## RE “NERINGAH” SENIORS HOUSING AND HEALTH FACILITY (SSD-45121248) SUBMISSION

We refer to the above State Significant Development Application (SSD) submitted by Hammondcare at No 2-12 Neringah Avenue South, Wahroonga (referred to as No 4-12 Neringah Avenue in the application).

We are writing on behalf of the Owners of **Strata Plan 100500** known as the “**The Sirius**” apartments at 14-18 Neringah Avenue South, Wahroonga. Our client’s property directly abuts the northern boundary of the subject site. Refer to **Figure 1** below.

Figure 4 – Proposed Site Plan with No 14-18 Neringah site notated

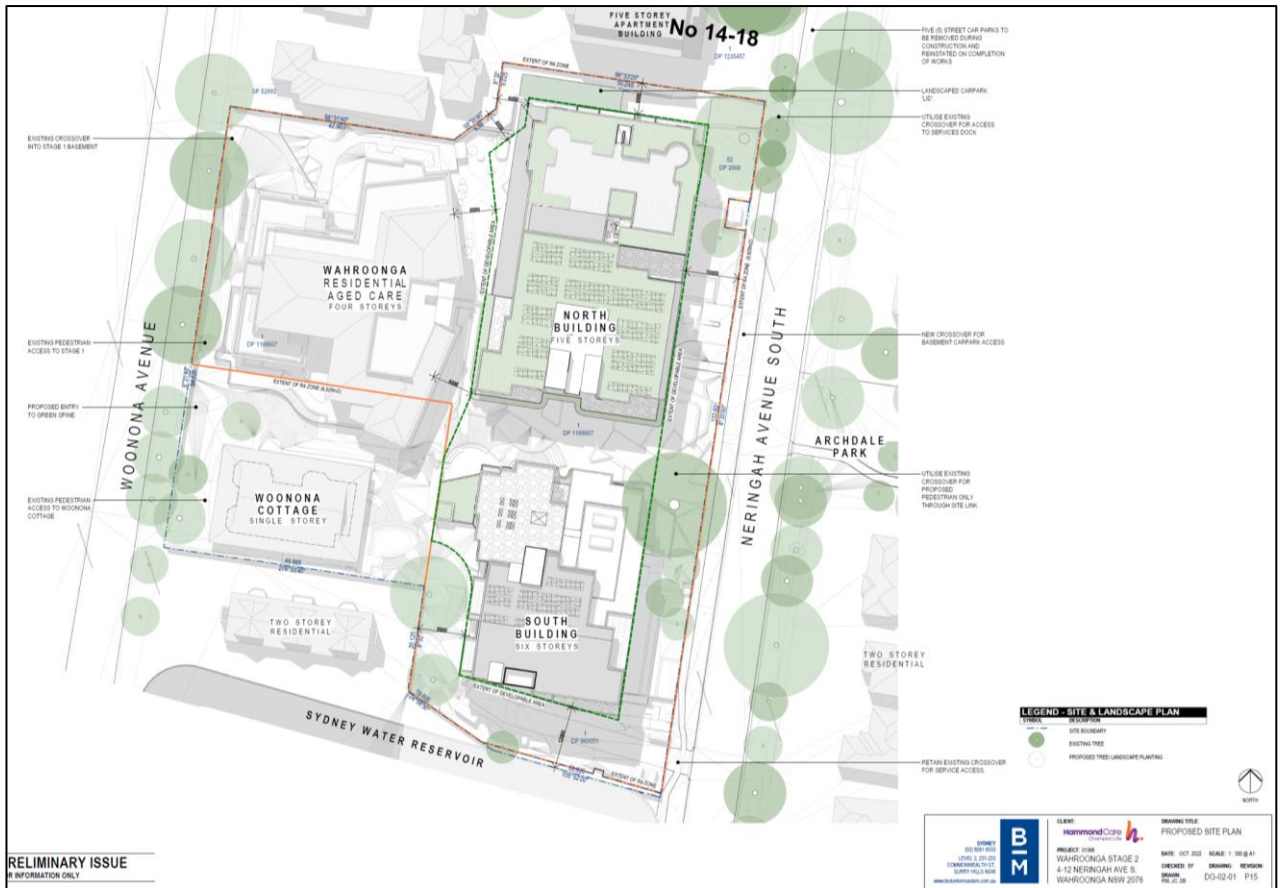
- b. **Amenity issues for Driveway Location:**- The location of the service vehicle / truck entry adjacent to the northern boundary means that truck deliveries/laundry pickups are more impacting on residential neighbours at No 14-18, whilst achieving amenity benefits to the proposed development. Locating the driveway on the northern/downhill side has functional attributes for the development which are acknowledged. **However, the location of the driveway in close proximity to “The Sirius” apartments means that any usage will impact on the acoustic amenity for residents with south-facing rooms, particularly with respect to early morning garbage/laundry/food delivery truck arrivals and out of hours ambulance emergencies.** The provision of a “lid” over the basement entry structure and enclosing walls on the northern and western sides is a band-aid solution which is only necessary by virtue of the site design that locates a noise generating use in close proximity to neighboring residences. An alternative design would have been to locate the service vehicle entry further to the south, preferably incorporated into the building design and not directly abutting the neighbour boundary.

While generous landscape setbacks and pedestrian pathways have been provided to the brick reservoir building to the south, there are minimal setbacks for the service vehicle entry provided to sensitive residential neighbours to the north. **Furthermore, the opening and closing of the metal entry roller door presents acoustic issues for the adjoining Sirius apartments as trucks/ambulances arrive/depart.** Refer **Figure 4** and **Figure 5** overleaf.

Figure 5 – Perspective with No 14-18 Neringah site location notated

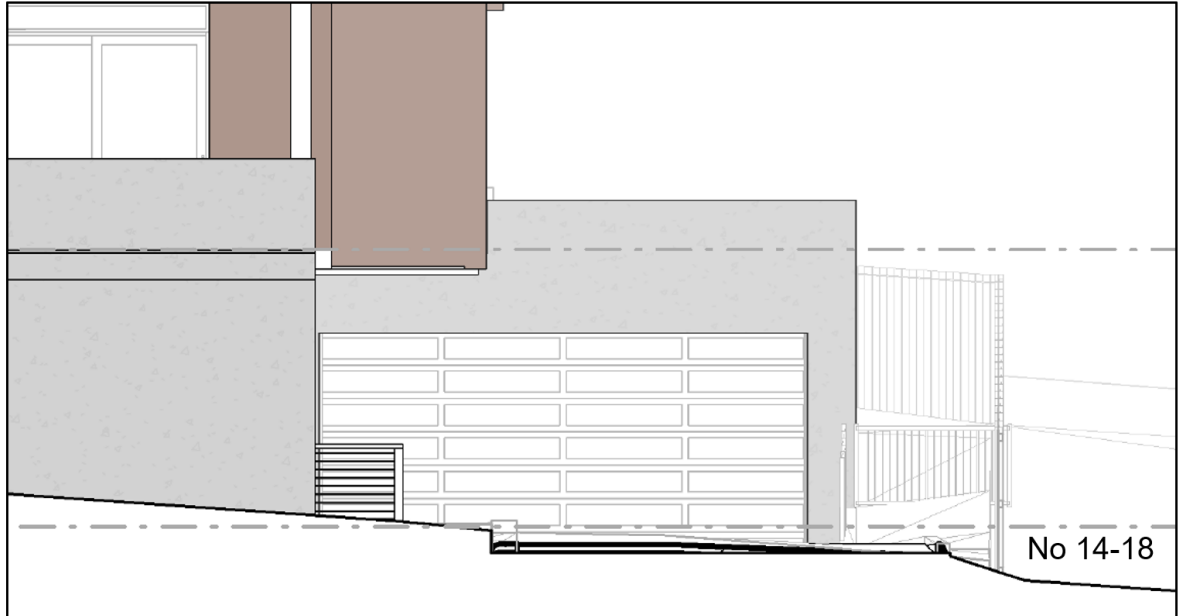
- c. **Basement entry structure form & setbacks:-** The loading bay/ambulance carpark (RL195) and “landscape lid” to the basement entry structure (RL199.525) means that basement entry structure pops above the natural ground level (ERL 197) by approximately **2.5metres** with only a narrow **1.63m** setback to No 14-18 boundary. The basement entry structure is illustrated in **Figure 5** below.

No sections / details are provided in the exhibited documents to explain planting area (soil) dimensions having regard to ground levels, any physical separation of soil from the basement entry structure, stormwater pipes (Ø150) and side boundary fencing/retaining walls.

**Figure 6** – Extract East elevation (Drawing AR-DG-20-N1) with No 14-18 notated

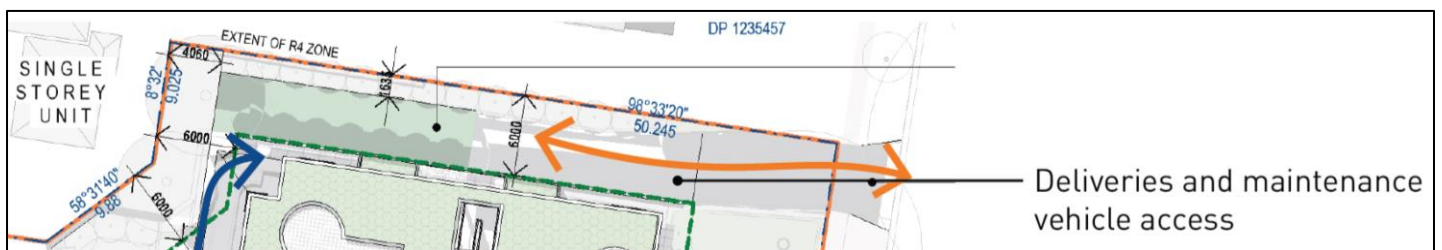
Elevation Drawings are also unclear how this narrow setback area is being treated. Refer **Figure 6** below.

The proposed row of Blueberry Ash (45L pot size) typically have 4m wide canopy, so that the trees will be significantly constrained by basement walls and side boundary fencing. Access for tree and stormwater pipe maintenance within the 1.63m wide dimensioned space may also present practical challenges as the trees mature in the confined space.

Figure 8 – Roof landscape Plan Source: Arterra

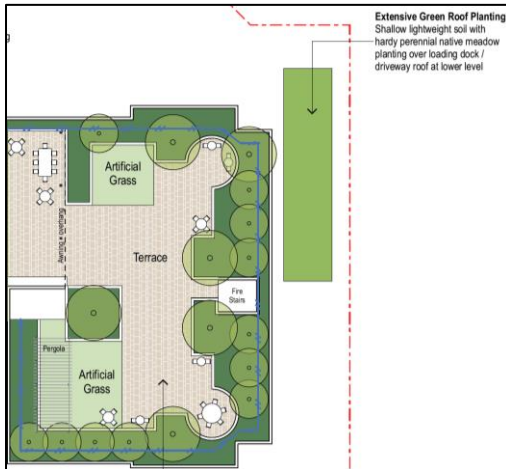
- e. **Landscape Treatment:** - The basement entry structure “lid” is shown on landscape plans to comprise “*Shallow light weight soil with hardy perennial native meadow planting over loading dock/driveway roof at lower level*” as denoted in **Figure 8**. Hence the side setbacks behind the building line which are ordinarily 6metres wide deep soil planting zones to provide tall vegetative screening between RFB developments in Ku-ring-gai, is not provided to any meaningful/effective degree.

Figure 10 – Swept Path Testing (MRV) Source: McLaren Traffic Engineering

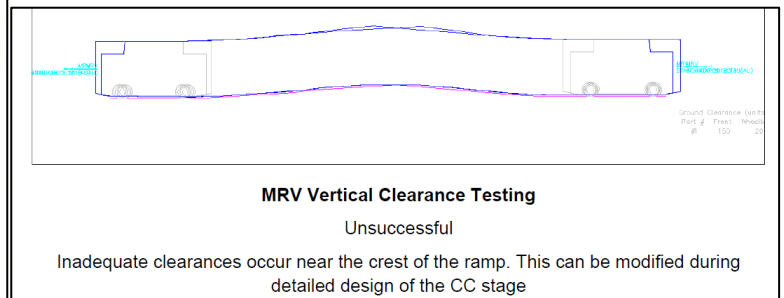
The above Annexure E *Swept Path Testing* to the submitted Traffic Report illustrates the ramp grades do not accommodate 8.8m Medium Rigid Vehicles (MRV). It is further noted that the ramp testing did not include Hammondcare’s larger **9.38m length laundry trucks** which would presumably also fail the test.

**Clarification of what changes might be required to facilitate ingress/egress of 8.8m and 9.38m trucks along the service vehicle driveway ramps is requested to be provided by the applicant to assess the redesign incase it has detrimental knock-on effects.** Provision of workable driveway design should be assessed at DA stage (not CC stage) given the driveway is immediately adjoining No 14-18 boundary and any adjustments could result in additional impacts.

Figure 11 – Tree Retention Value Plan

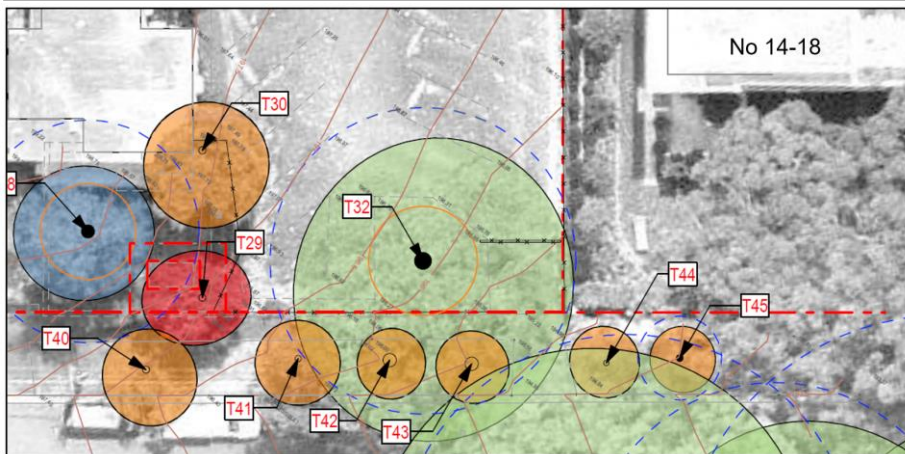
The proposed removal of street trees is referenced in the submitted Arboricultural Report at page iv and Tree Retention Value Plan (Drawing LT-DG-01-E0) at **Figure 11** below. T44 and T45 are located on the road reserve in front of “*The Sirius*” apartments are identified for removal.

Figure 12 – Tree Planting Plan LA-DG-04-E0

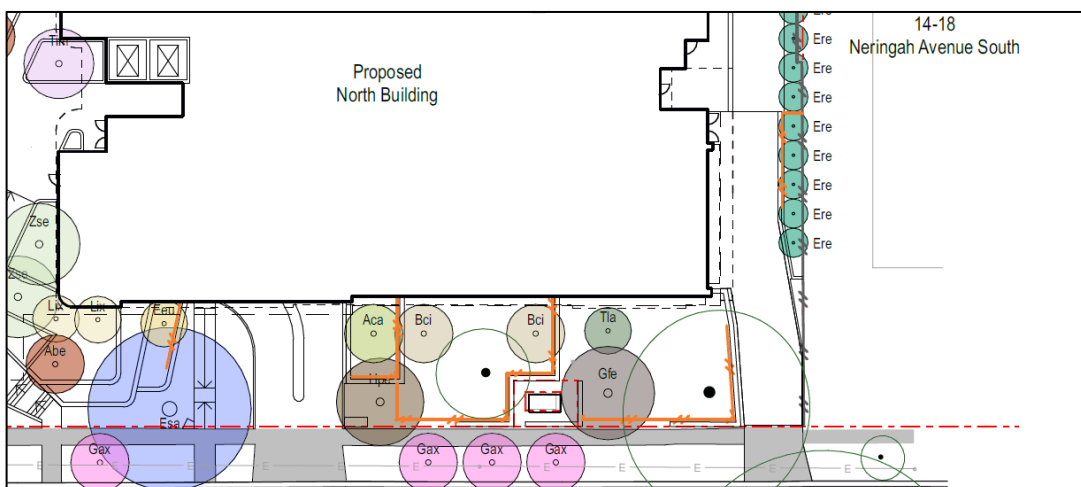
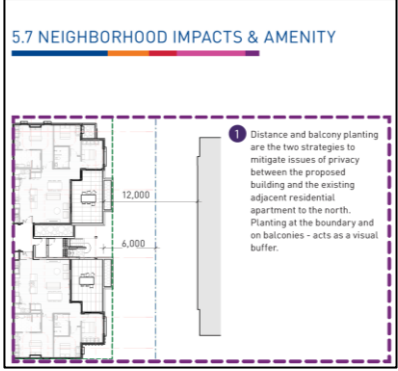
However, the Tree Planting Plan Drawing LA-DG-04-E0 (refer **Figure 12** below) is inconsistent with the Arborist report and does not show removal/replacement of Trees 44 and 45.

**The tree removal/replanting for the road reserve in front of No 14-18 should be clarified by the applicant.**
